Location: **Former Exxon Station, 3055 35th Avenue, Oakland**

ACEH LOP#: **RO-0000271; GeoTracker #: T0600100538;**

Subject: Response to Technical Comments - Work Plan for Additional Site Investigation
Site: Former Exxon, 3055 35th Avenue, Oakland, CA, Fuel Leak Case RO0000271
GeoTracker Global ID T0600100538

FIGURE 20R
Project 2X103.F

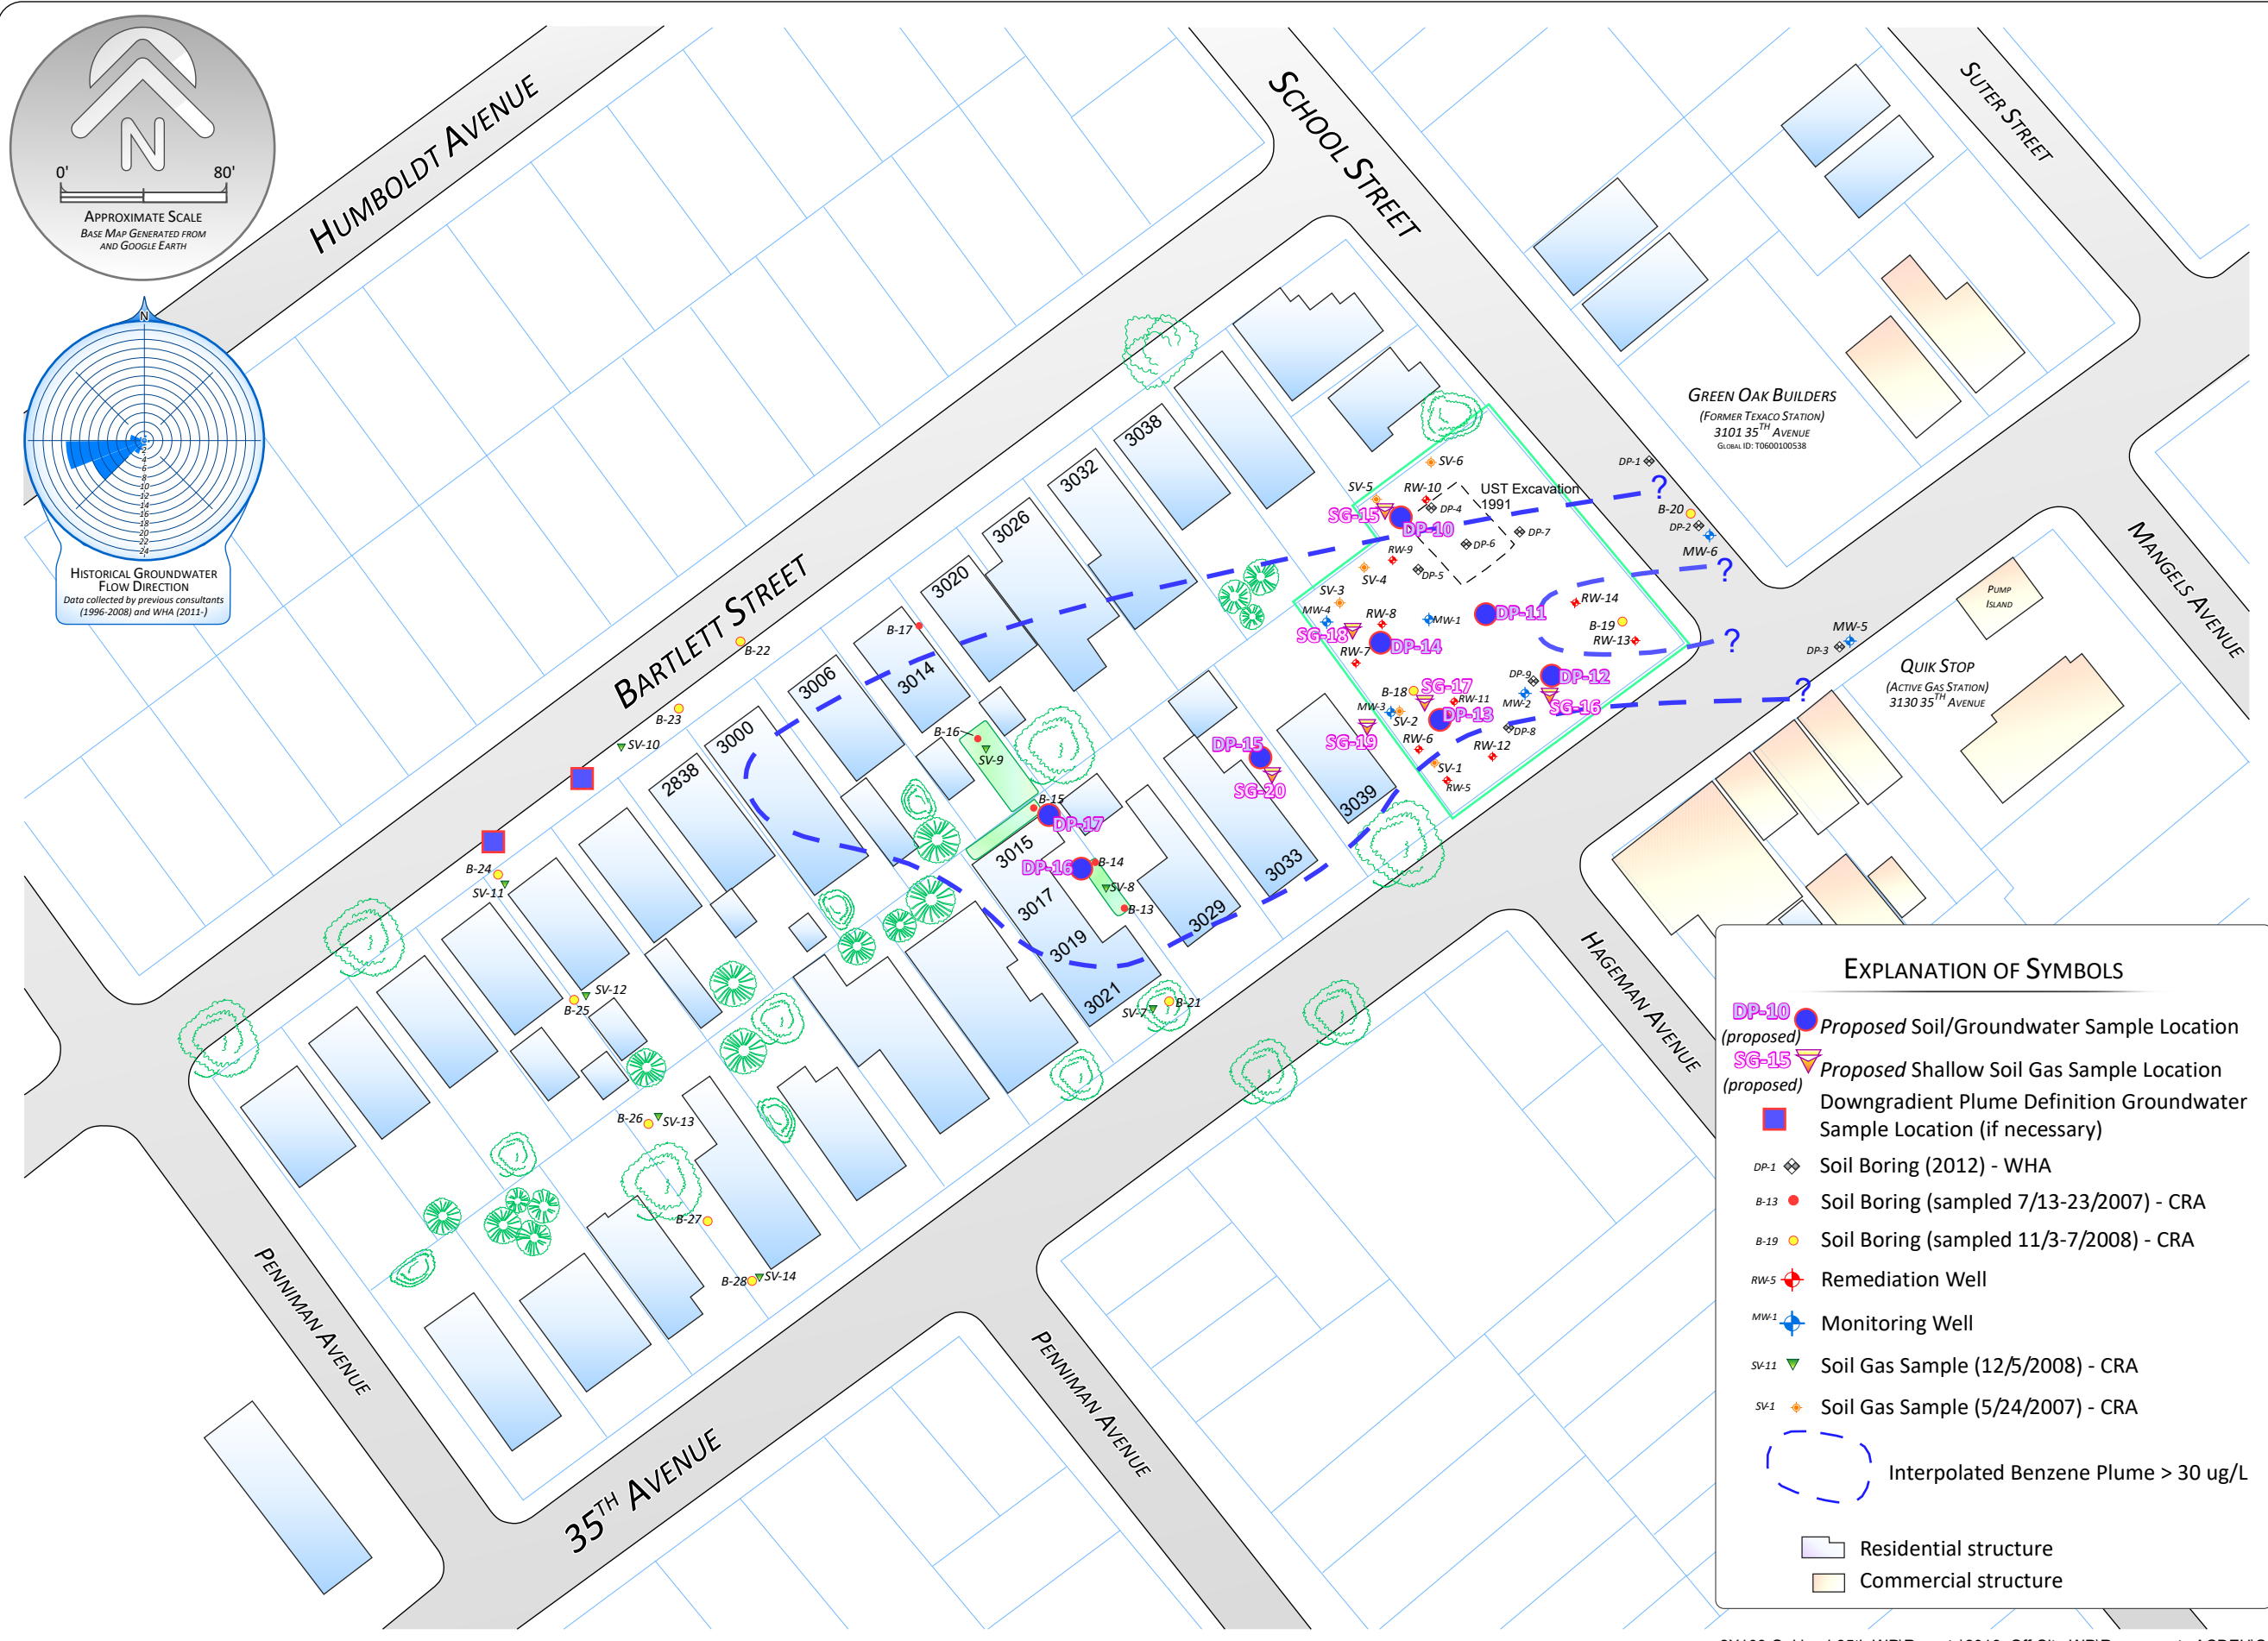
As directed by ACDEH, we have added an additional soil boring in the middle of the site to adequately address Direct Contact and Outdoor Air Exposure (DCOAE) and revised Figure 20 to show the location of the additional soil bore. The revised figure is attached (Figure 20R). Figure 20R was provided to ACDEH staff by electronic mail on February 1, 2017. To date we have not received feedback regarding Figure 20R. Also as requested, we have assigned boring identification labels in Figure 20R for future reference. We believe the additional soil boring in the center of the site, DP-11, in conjunction with the other proposed borings, will provide sufficient data to adequately addresses the DCOAE criteria. We note that Figure 4 of the *Work Plan* summarizes shallow soil sample analytical results from previous borings at the site that can help with the DCOAE evaluation.

With regard to bore B-15, as described in our February 1, 2017 electronic-mail to ACDEH staff, this location appeared inaccessible during our foundation survey due to the presence of a storage structure, but we believe we can access and collect samples close to this location as shown on revised Figure 20R, boring DP-17.

With the addition of boring DP – 17 we note that discrete groundwater samples will be collected at three offsite locations as depicted on Figure 20R.
